RE: **Sunset West-Unit II**
9016 & 9020 Suncrest Rd, 9101 Sunbow Ave. SW
Pad Certification for lots 16, 26 & 27 - Approved
Engineers Stamp Date 8/26/10 (M09D004A)
Certification Dated: 10/20/16

**Re: Sunset West Unit II Lots 16, 26 and 27 Grading and Drainage Plan
Engineer's Stamp date 8-26-10 (M09/D004A)**

SUBJECT: *SUNSET WEST, UNIT 2*
TEMPORARY RETENTION POND RECLAMATION IMPROVEMENTS
L09/D004A
CPN 499182

**Re: Sunset West Unit II Lots 16, 26 and 27 Grading and Drainage Plan
Engineer's Stamp date 7-26-10 (M09/D004A)**

SUNSET WEST V2

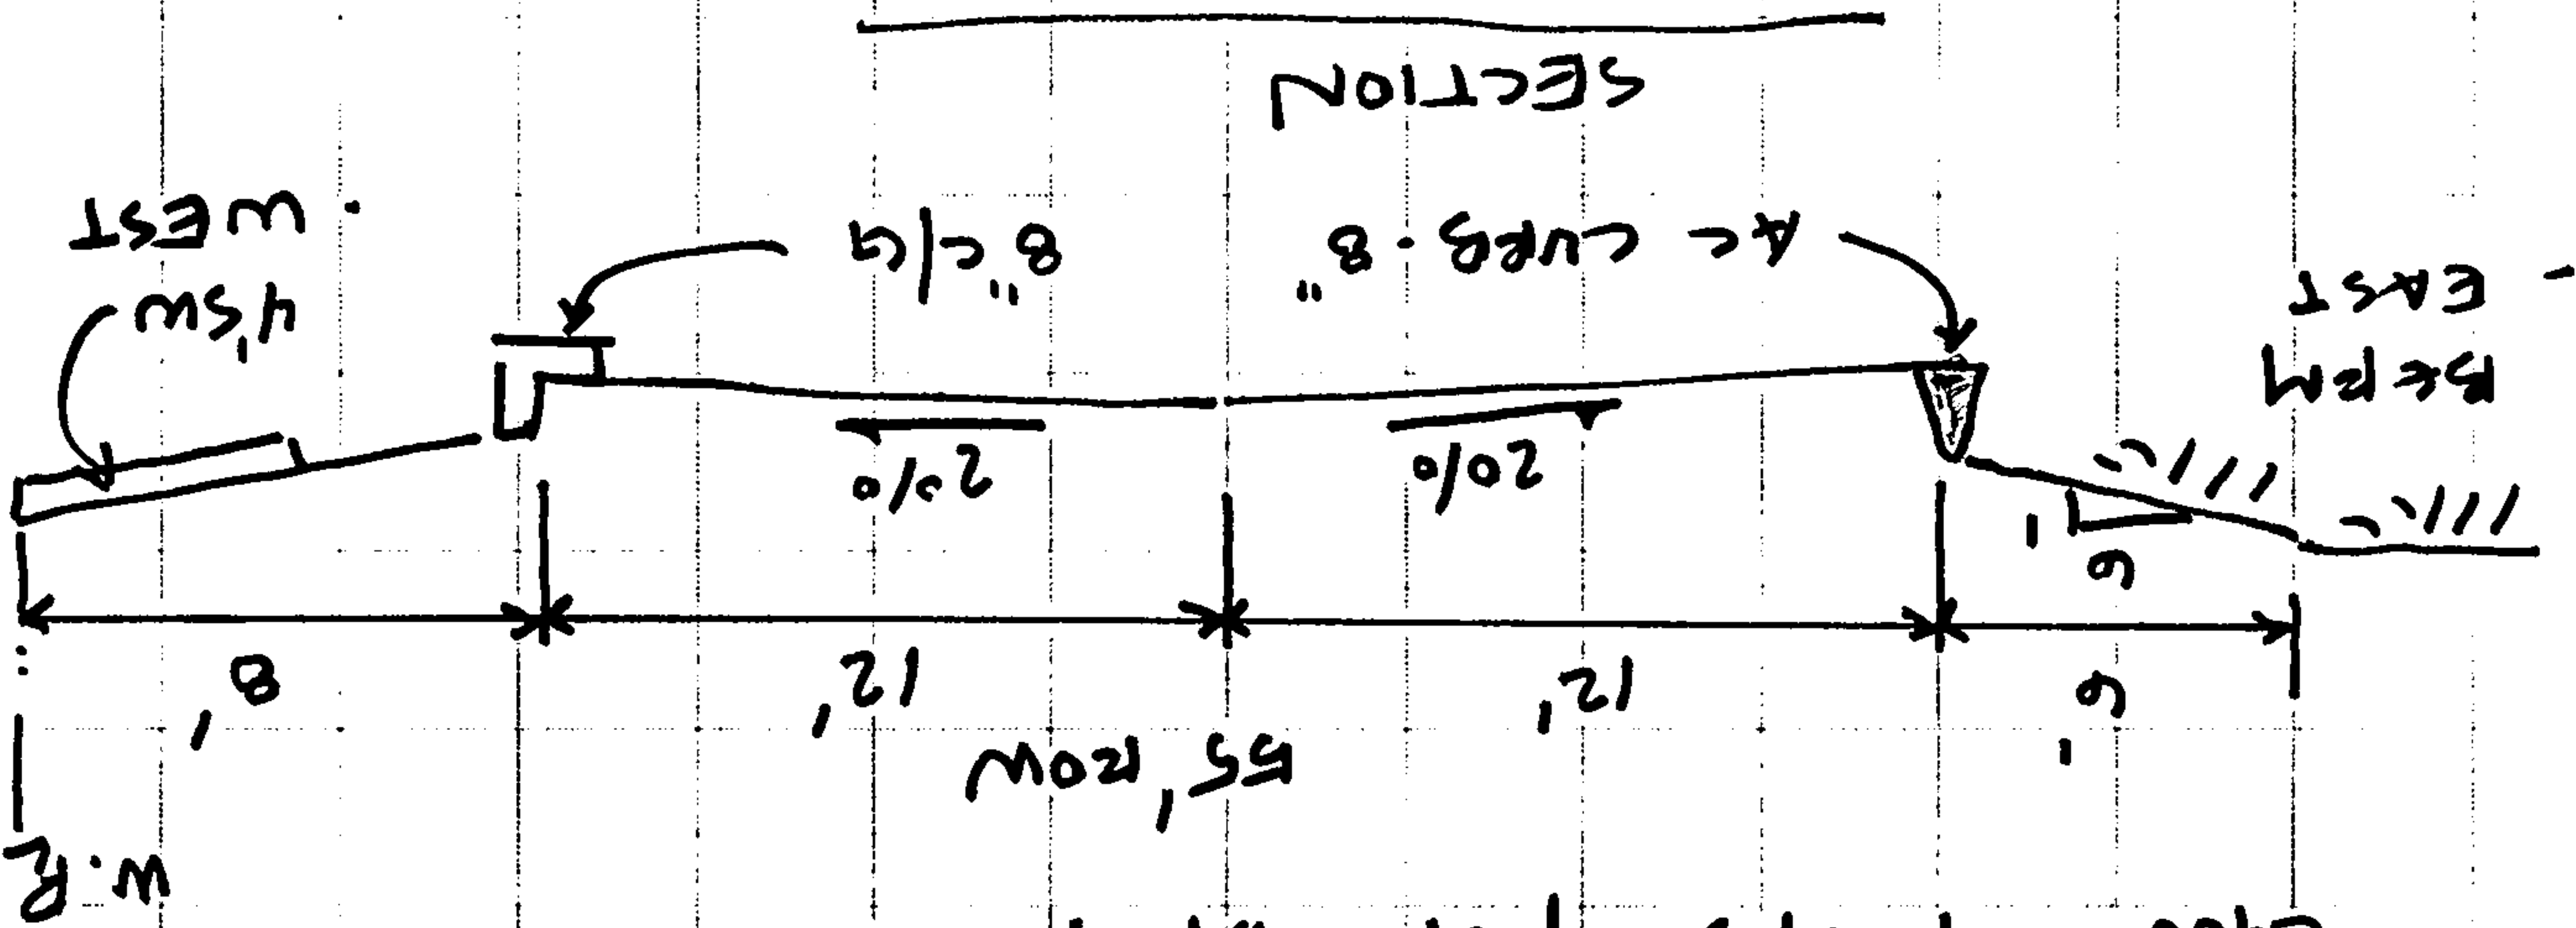
- Provide as-builts for the downstream storm drain.
- It appears that 90th street does not have the capacity if the pond is removed. 90th Street has not changed since the subdivision was built with the pond. The Work Order CPN 4991.90 shows a 25 foot section curb face to edge with a temporary asphalt curb, whereas your submittal specifies 32 ft face to face with standard curb and gutter on both sides.
- It appears that Keyed Note 10 is not required.
- It appears the eastern callout for Keyed Note 6 is extraneous.

1. We understand that Work Order will not be issued until completion of the 86th/Sage Storm Drainage Project.
2. We propose to construct an earthen berm and repair the existing asphalt curb along the east side of 90th street to improve street carrying capacity. See attached calculations and details.
3. The Keyed Notes have been revised to identify public-vs-private work items.

① STREET DEPTH CHECK

Q100 = 90 cfs PER DPM

④ AT TOP OF CURB

③ AT P/W (WEST)

$$\Rightarrow Q = 73.5 \text{ cfs}$$

$$73.5 < 90 < 113.6$$

$$\Rightarrow Q = 113.6 \text{ cfs}$$

$\Rightarrow Q_{100} = 90 \text{ cfs} - \text{will top the curb but stay within ROW.}$
